From: Peter Galvin
Sent: 6/12/2021 1:33:27 AM
To: Council Northernbeaches Mailbox
Subject: Submission DA2021/2097
Attachments: 918 Submission DA2021_2097_ 051221.pdf;

Re: DA2021/2097 Submission - 918 Barrenjoey Rd Palm Beach

Bushfire Assessment and Geotechnical Advice

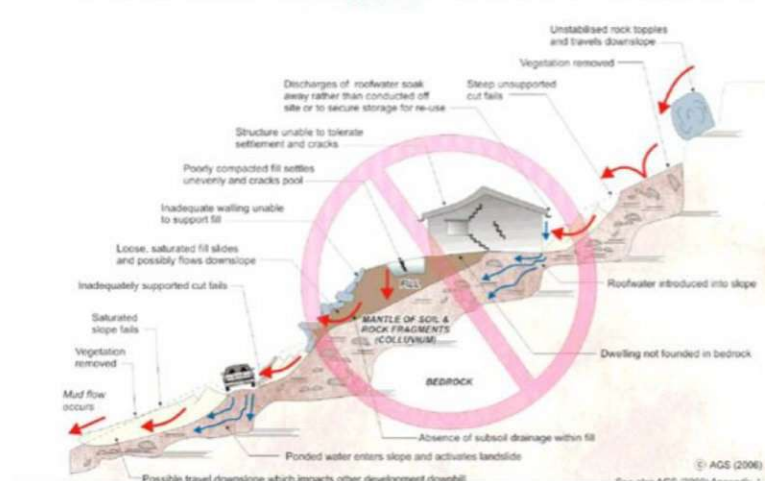
The bushfire assessment by the authors own admission in the assessment table is considered low which conflicts with a high BAL rating of 40.

As per best practice, the bushfire report should be prepared in accordance with other environmental and geotechnical reports particularly on sloping sites where vegetation should be retained and cuts kept to a minimum.
